Administrative Approval Action

Case File / Name: ASR-0057-2022
DSLCL - 7691 ACC BLVD

REQUEST: Development of a vacant 1.688 acre/73,533 sf tract zoned PD (Ruby Jones Master Plan -OX UDO base district). A proposed 8,080 gross square foot office building consisting of 3 units for future proposed uses with associated parking and landscaping, screening designs per MP-1-00 and the Raleigh Unified Development Ordinance (UDO).

FINDINGS: City Administration finds that this request, with the below conditions of approval being met, conforms to the Unified Development Ordinance. This approval is based on a preliminary plan dated March 28, 2023 by TIMMONS GROUP.

JOB NO.
53677
SHEET NO.
C3.1

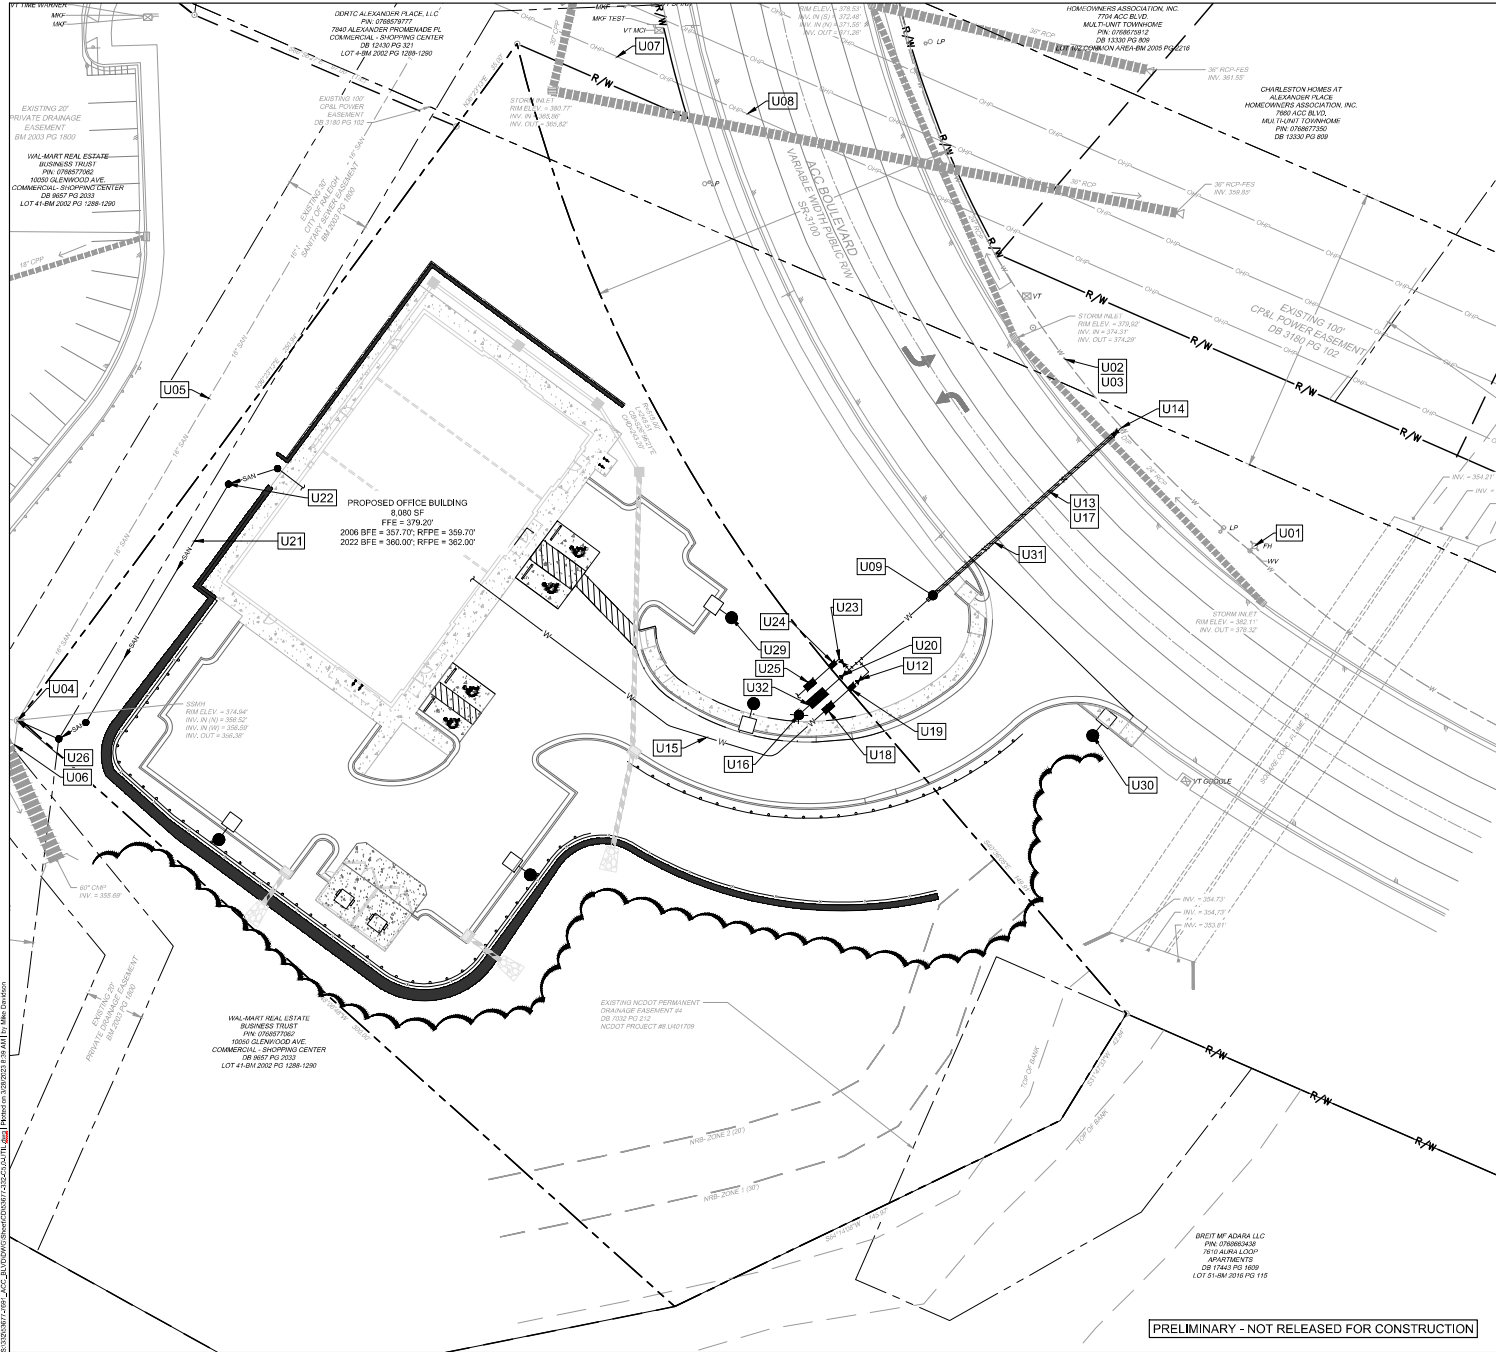
1. The greenway easement, as shown on Sheet C3.00 within the preliminary plan, shall be dedicated prior to, or in conjunction with the recording of a map in any phase affected by the greenway.
